September 7, 2023  
GS# 320-092, PEARL PROB. & PAROLE RE-ROOF  
Department of Corrections, Pearl, MS

### Addendum No. 1

SHEET  
**A201**  
 ROOF DETAILS

STAGING AND ACCESS LOCATIONS

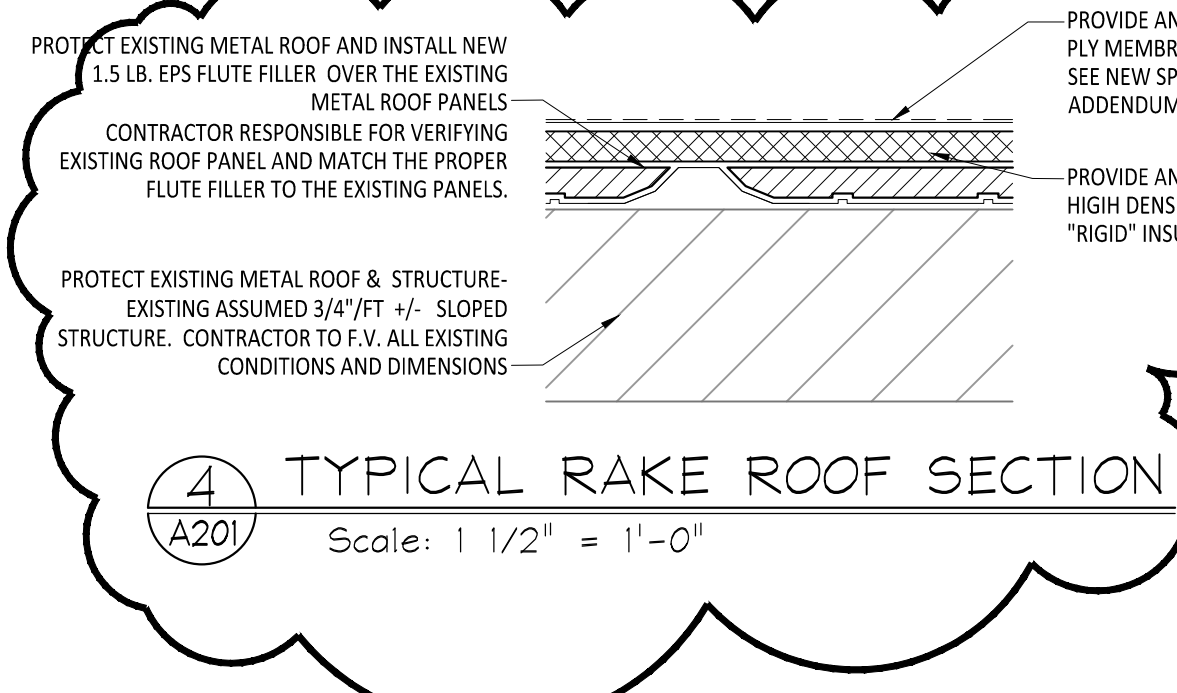
4. See the attached Staging and Access Points diagram for allowable storage/staging and access points as part of this addendum. Fencing and site repair requirements will apply to these and all other areas used.

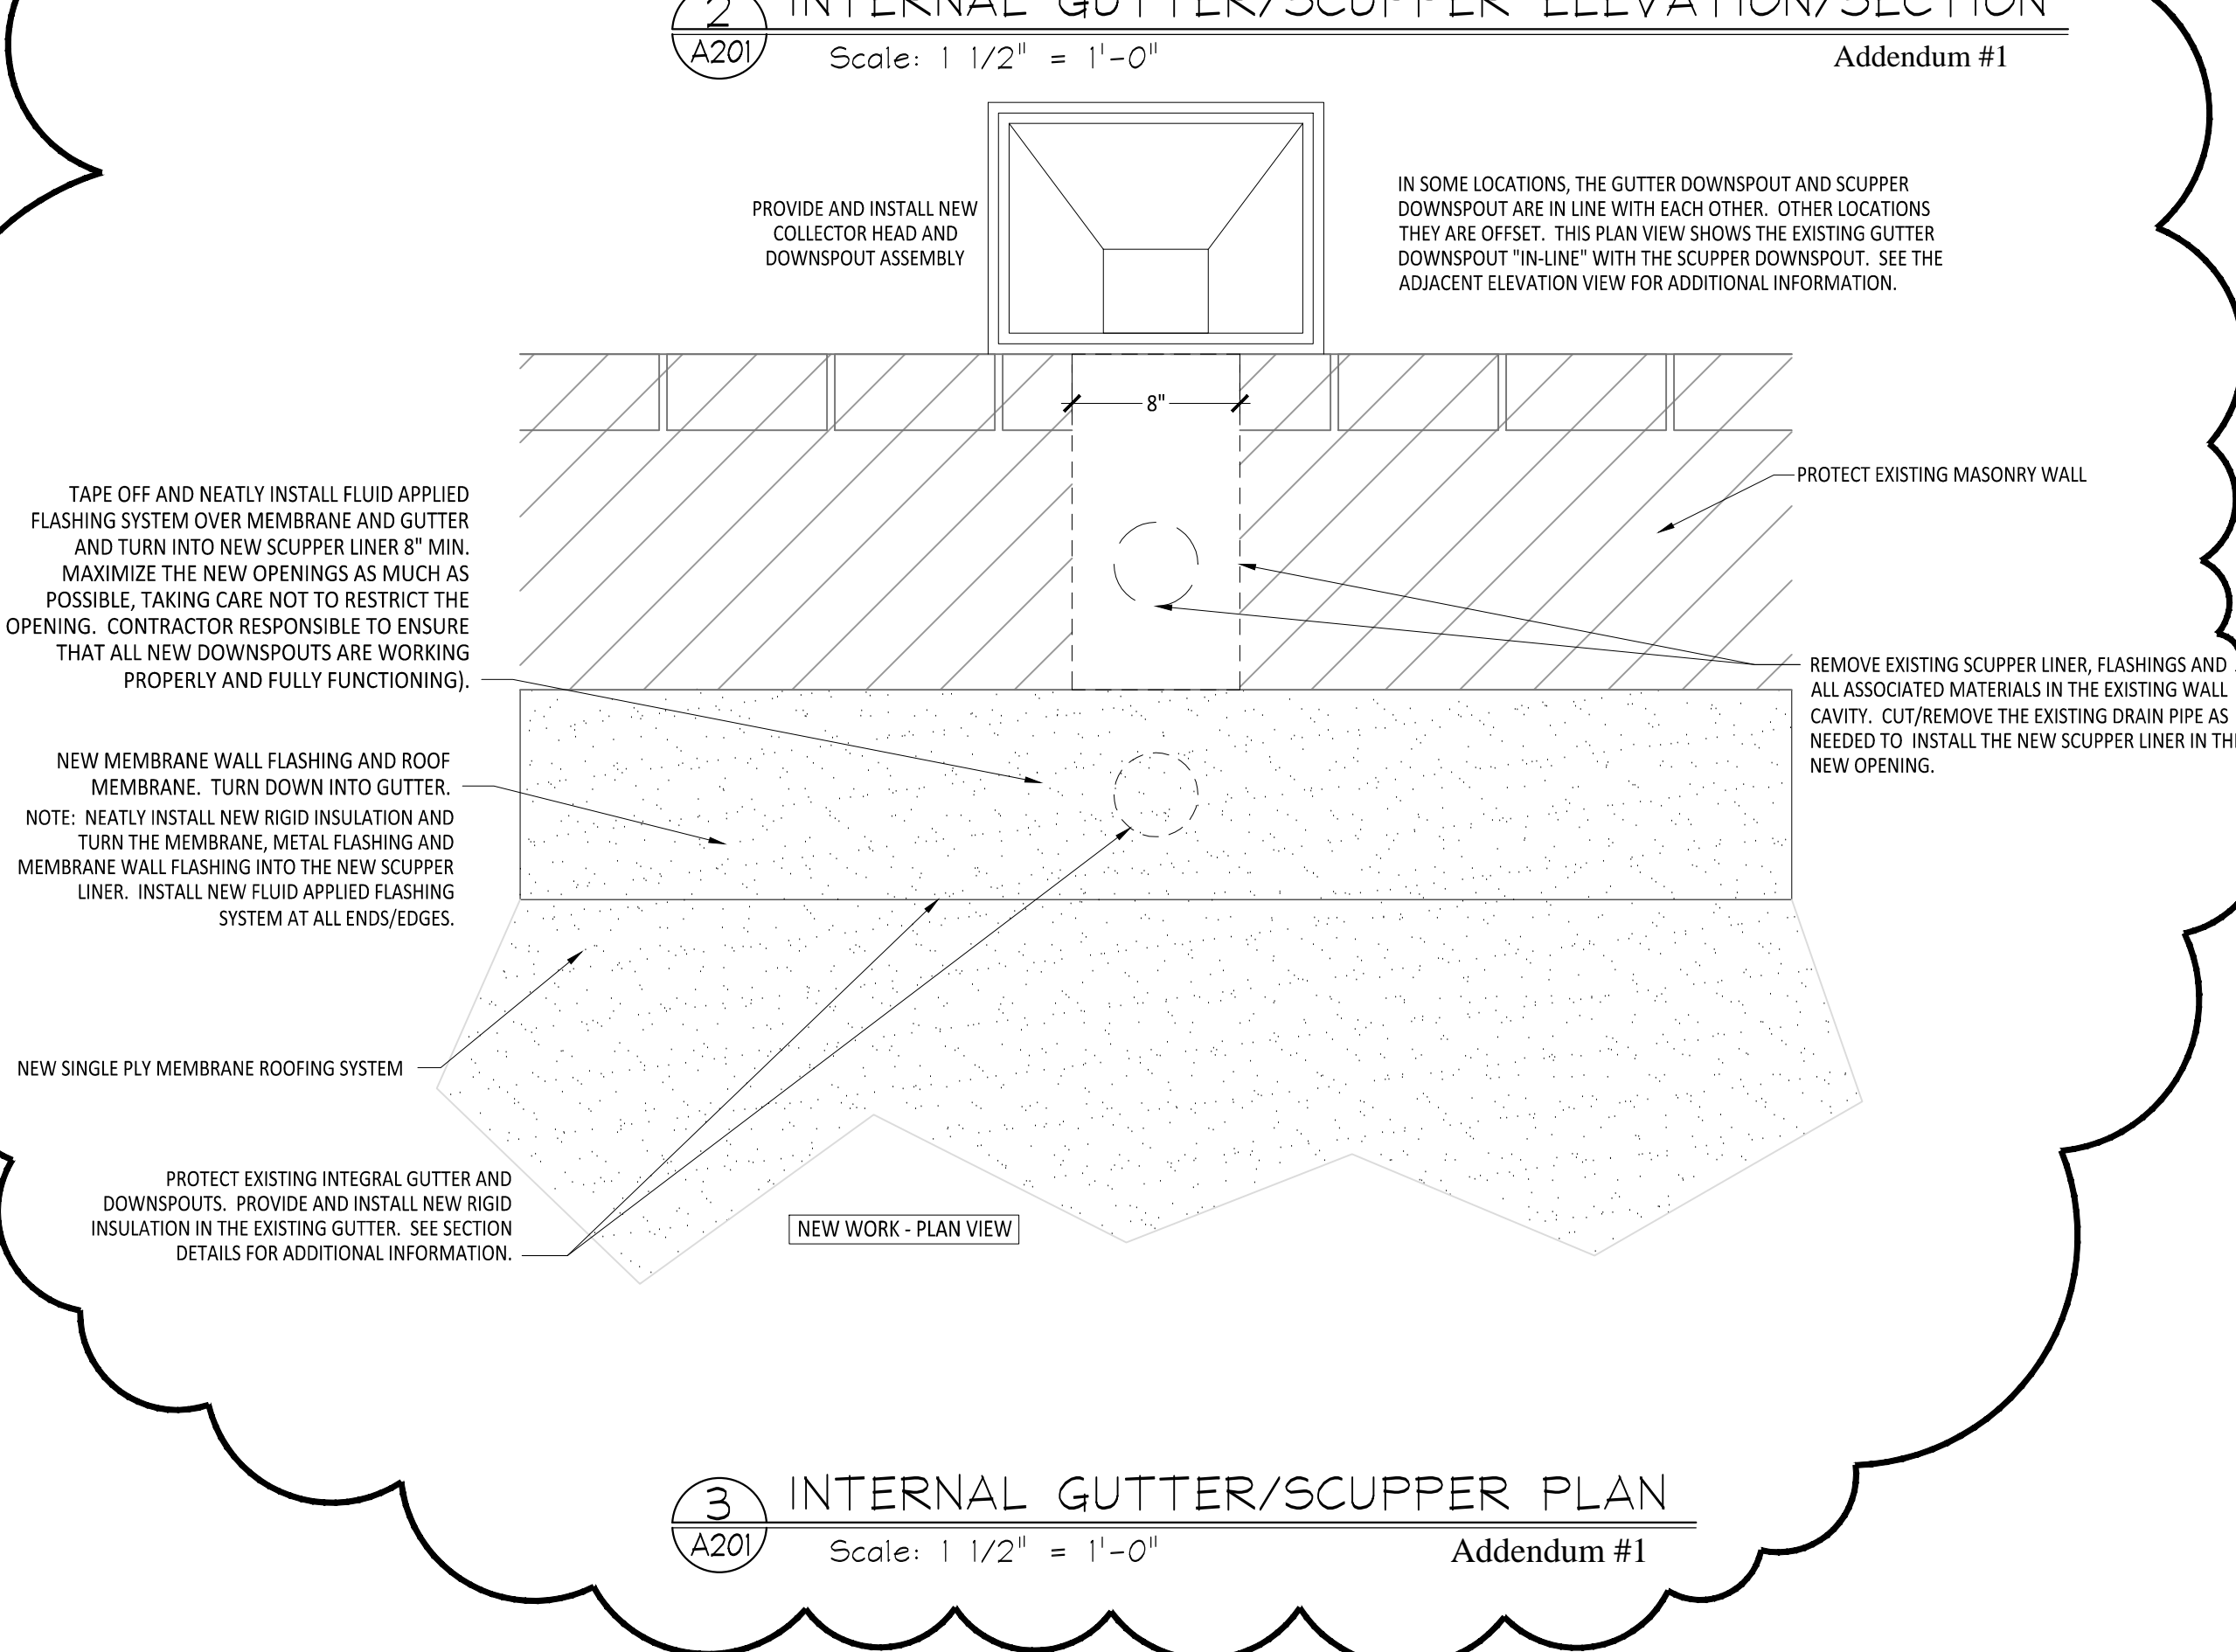
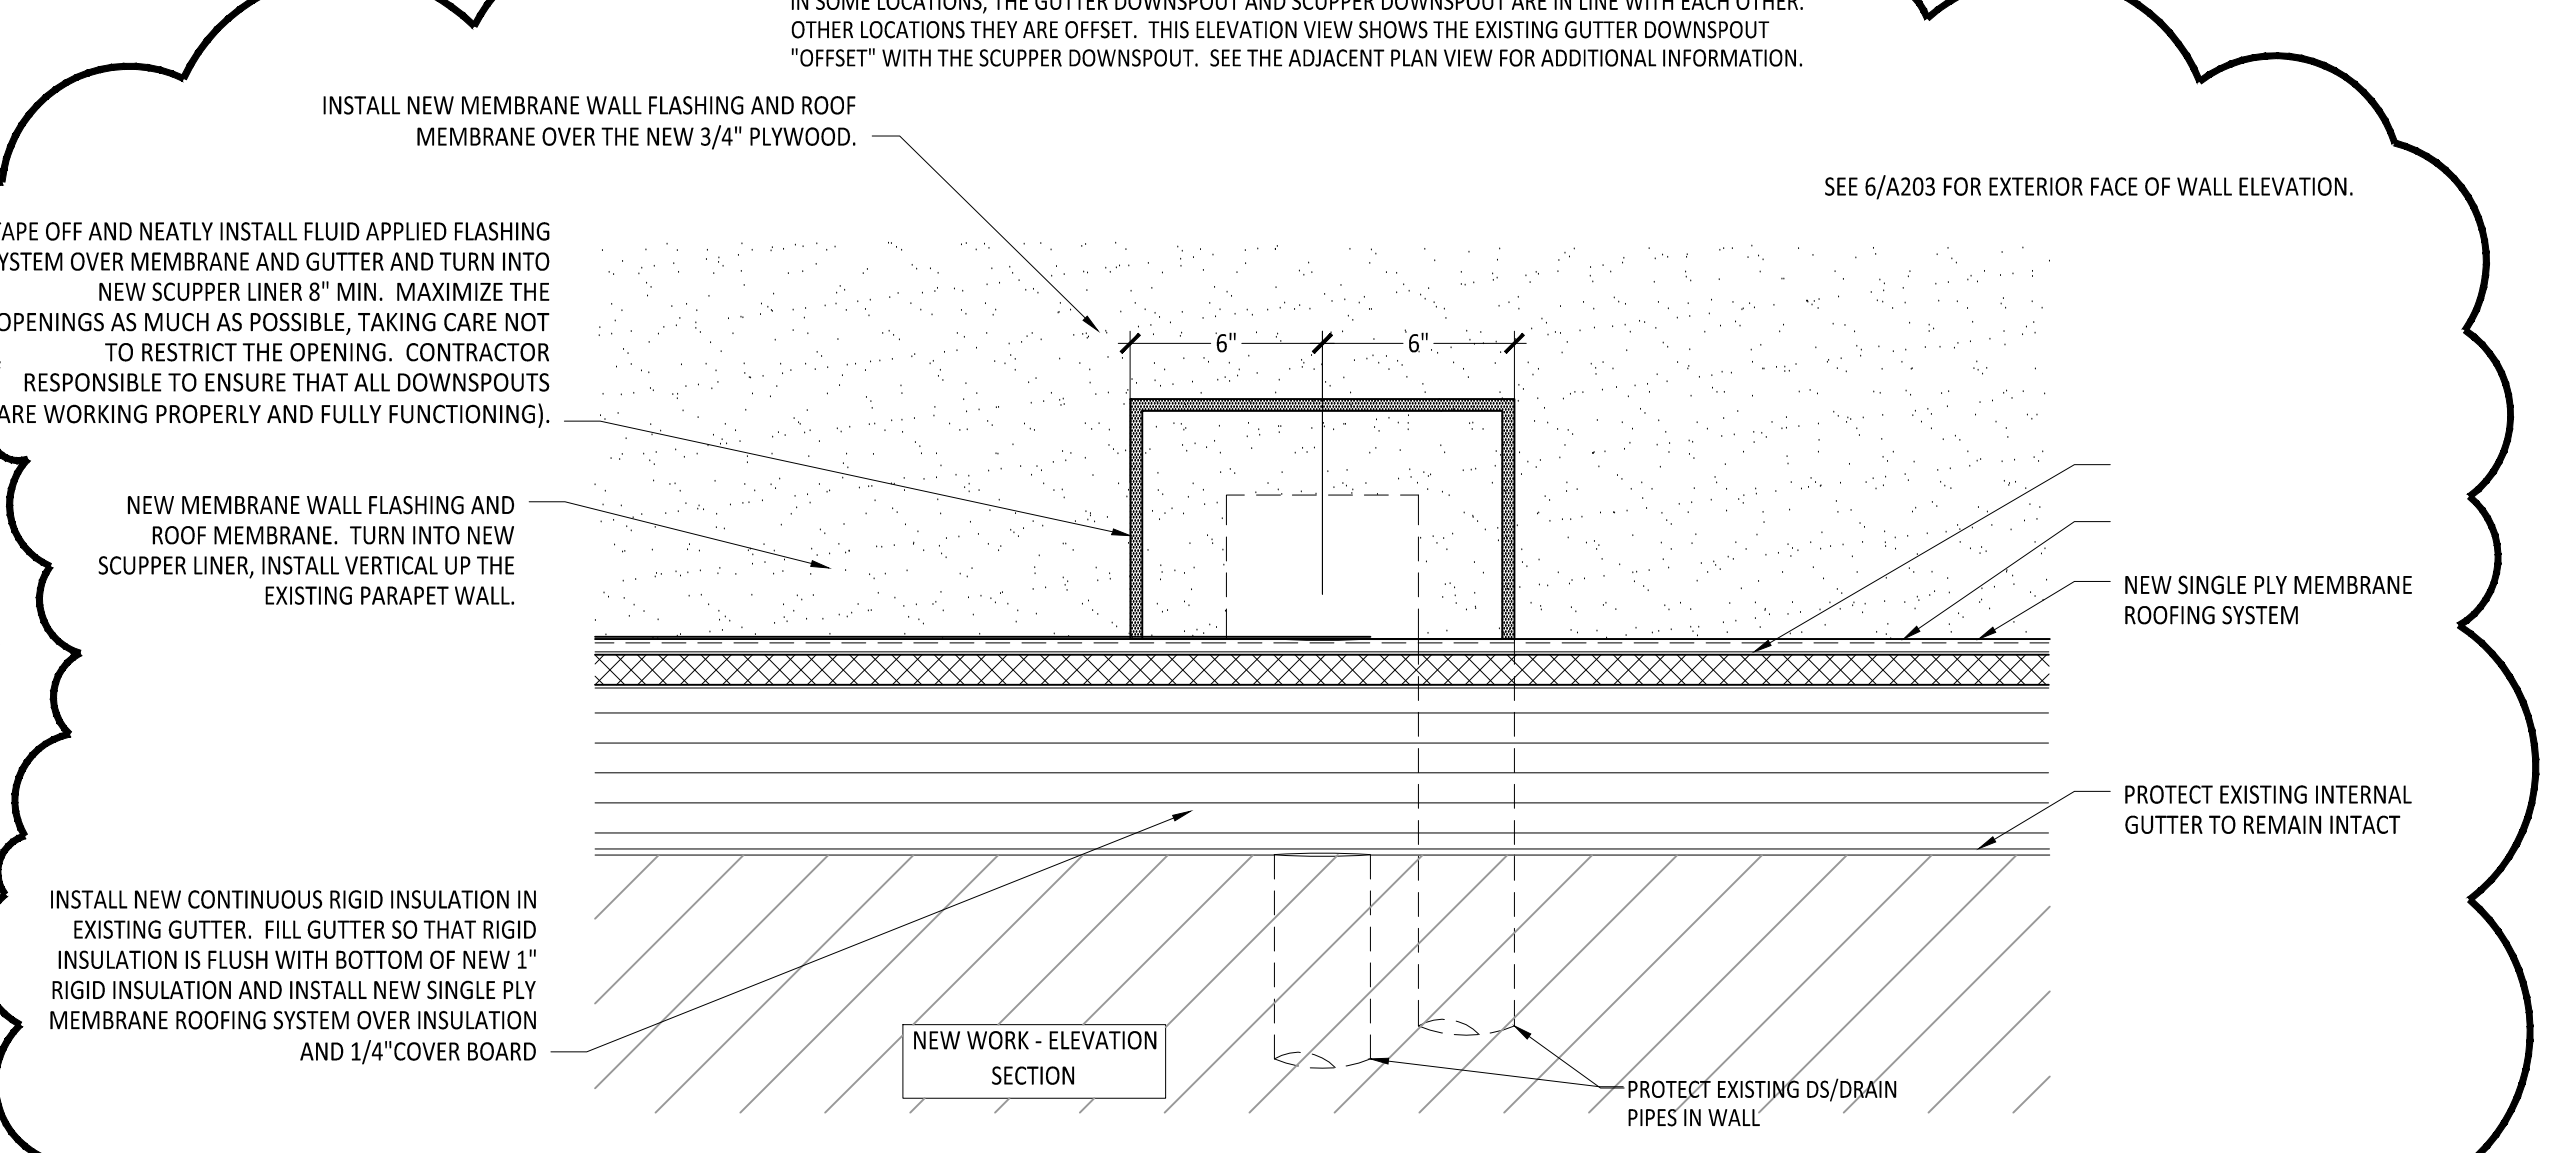
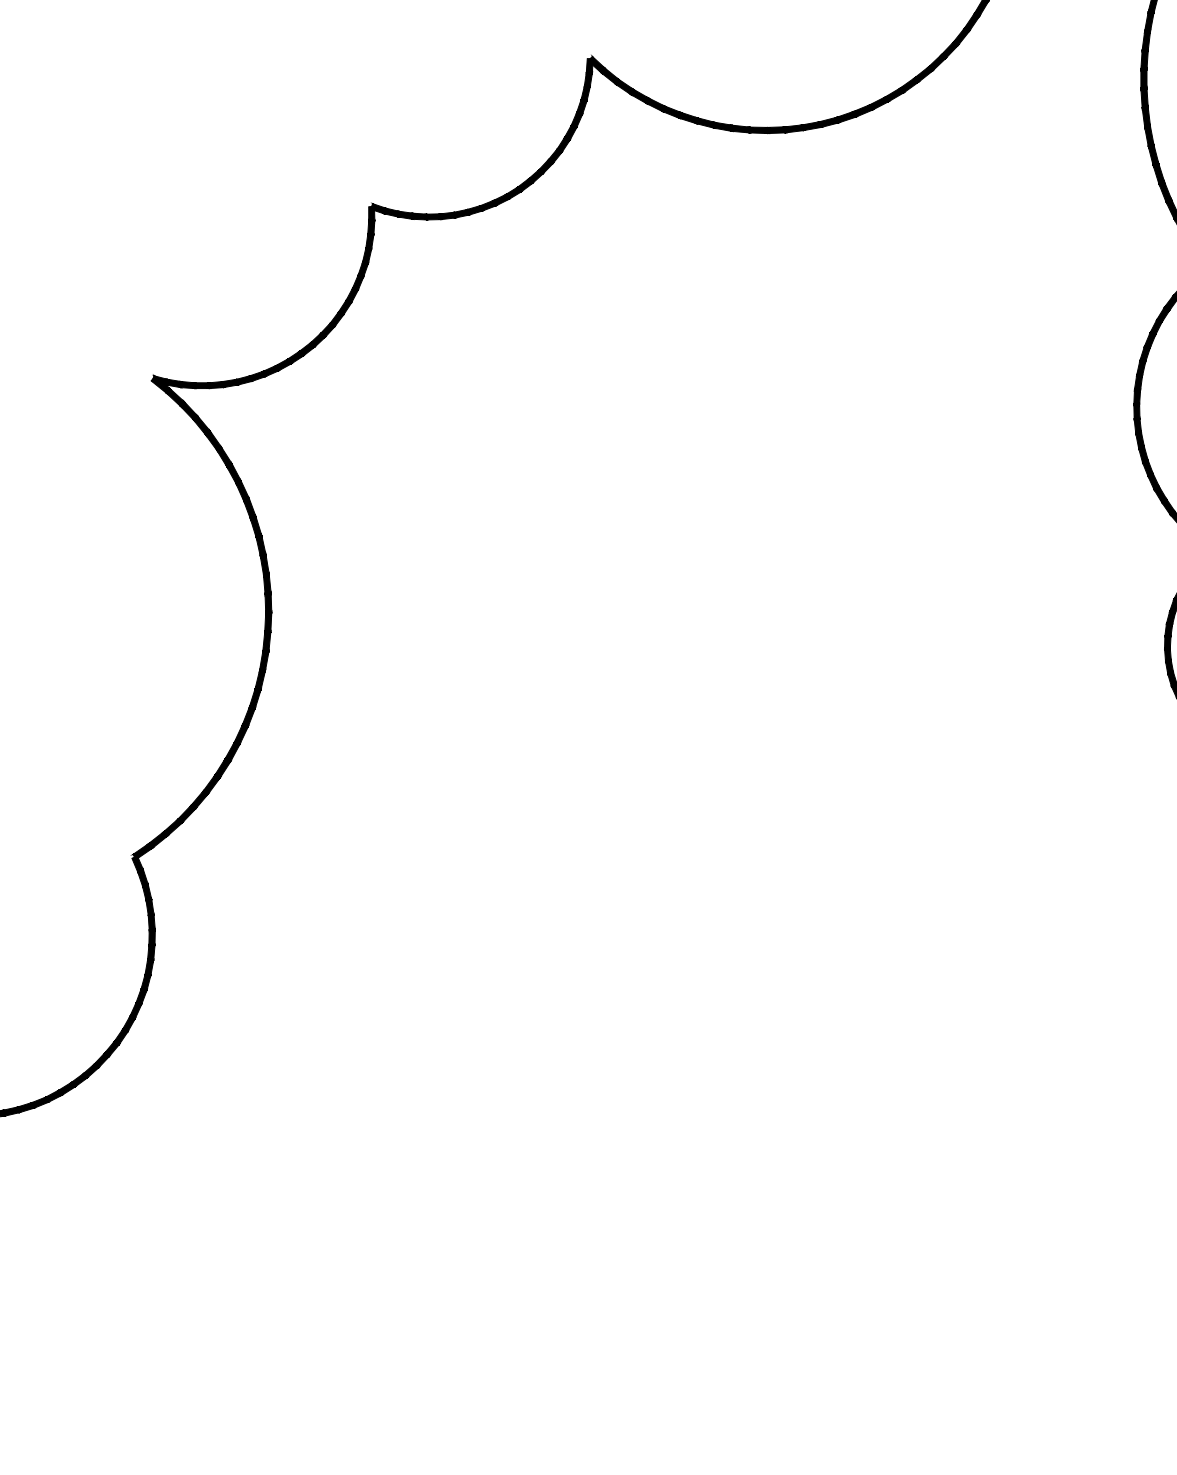
12. See the reissued drawing A201 for changes in the parapet detail and new through wall scuppers. Note that the new detail calls for infilling the existing integral gutter, creating new through wall scuppers and installing new collector heads and downspouts (verify locations). The scupper openings are to be 8" x8" minimum. New crickets will be installed between the new through wall scuppers. The exterior of the new scupper is to have a prefinished metal, 1-1/2" "picture frame" type flange around the perimeter in a color that reasonably matches the existing brick. The existing PVC drain outlets at grade will cut flush with the brick face and capped with a square piece of prefinished metal to match the brick color reasonably closely. The metal shall have hemmed edges and be attached to the brick with drive pins.

6. **See the reissued drawing A201 for changes in the parapet detail and new through wall scuppers. Note that the new detail calls for infilling the existing integral gutter, creating new through wall scuppers and installing new collector heads and downspouts (verify locations). The scupper openings are to be 8" x8" minimum. New crickets will be installed between the new through wall scuppers. The exterior of the new scupper is to have a prefinished metal, 1-1/2" "picture frame" type flange around the perimeter in a color that reasonably matches the existing brick. The existing PVC drain outlets at grade will cut flush with the brick face and capped with a square piece of prefinished metal to match the brick color reasonably closely. The metal shall have hemmed edges and be attached to the brick with drive pins.**
